Service Technical Information

MODEL NO.	XR-MD85 EZ
SUBJECT	Tape stop at FM recording

REF.No. :G - 99 - 047 - E0

DATE :01. NOV. 1999

MAIN C.B. PATTERN SIDE

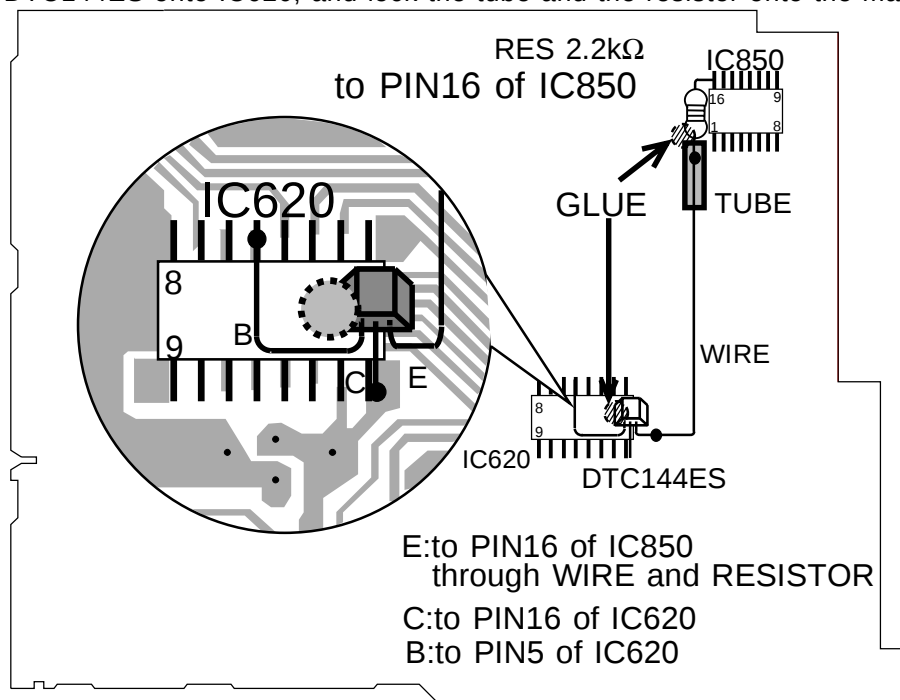
A tape stops in approximately 5 minutes after starting recording of an FM program on tape, using the model in question.

This problem occurs when an FM signal includes RDS signal.

Take the following steps:

1. Solder the base terminal of DTC144ES to pin 5 on IC620, and solder the collector terminal of DTC144ES to pin 16 of IC620.
2. Solder the emitter terminal of DTC 144ES to the wire, and let the wire in the tube.
3. Solder an end of the wire to the resistor.
Solder the other end of the resistor to pin 16 of IC850.
4. Lock DTC144ES onto IC620, and lock the tube and the resistor onto the main C.B. with glue.

After taking the above actions, RDS indication will not be updated during REC operation on tape.
